Access Compliance Report

Public Rights-of-Way

(Curb Ramps)

Intersection ID: 31540	Main Street: CALDWELL RIDGE PY	Cross Street: CARLEEN WAY DR	Location:	N
ADA ID: 3CD3A694BA94	Ramp Type: PerpDiag	Initial Pass/Fail: Fail	Overall Compliance: No	Severity Score: 8.75
Codes/Mitigation Info/Possible Solution		Field Measurements/Component Compliance

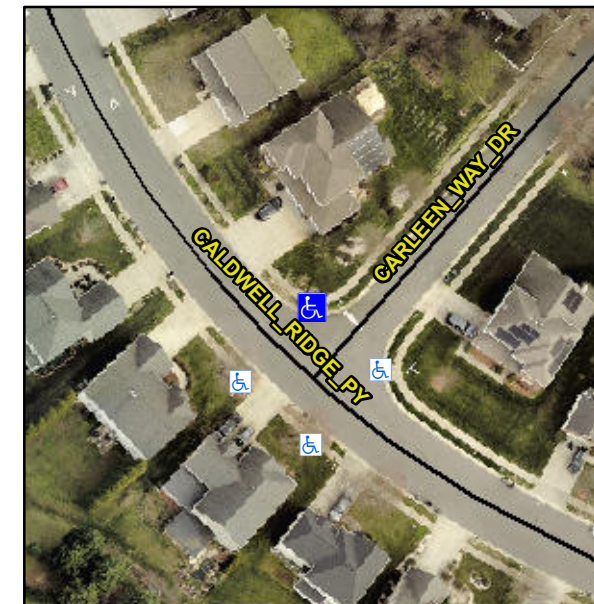
Not Found, R304.5.1

Compliance	Description	Data	Compliance	Description	Data
N/A	Ramp Length (in)	48.0	Yes	Ramp Slope (%)	5.2
No	Ramp Width (in)	46.0	Yes	Ramp XSlope (%)	1.7
N/A	Flare Type LT	N/A	N/A	Flare Type RT	N/A
N/A	Flare Slope LT (%)	N/A	N/A	Flare Slope RT (%)	N/A
N/A	Flare Traversable LT?	N/A	N/A	Flare Traversable RT?	N/A
N/A	Landing Length (in)	N/A	N/A	DWS Provided?	N/A
N/A	Landing Width (in)	N/A	N/A	DWS Contrast?	N/A
N/A	Landing Slope (%)	N/A	N/A	DWS Length (in)	N/A
N/A	Landing X Slope (%)	N/A	N/A	DWS Full Width?	N/A
N/A	Landing Curb? (Y/N)	N/A	N/A	DWS Offset (in)	N/A
N/A	Shared Landing?	N/A			
N/A	Gutter Ponding?	N/A	N/A	Gutter Slope (%)	N/A
N/A	Gutter Lip Ht (in)	N/A	N/A	Gutter X Slope (%)	N/A
N/A	Painted X Walk1?	No	N/A	Painted X Walk2?	No
	X Walk 1 Direction	To SW		X Walk 2 Direction	To SE
N/A	X Walk 1 Width (in)	N/A	N/A	X Walk 2 Width (in)	N/A
	X Walk 1 Slope (%)	7.0		X Walk 2 Slope (%)	5.1
	X Walk 1 X Slope (%)	2.0		X Walk 2 X Slope (%)	4.8

Remove & Replace Curb Ramp With Two New Directional Ramps or Equivalent.
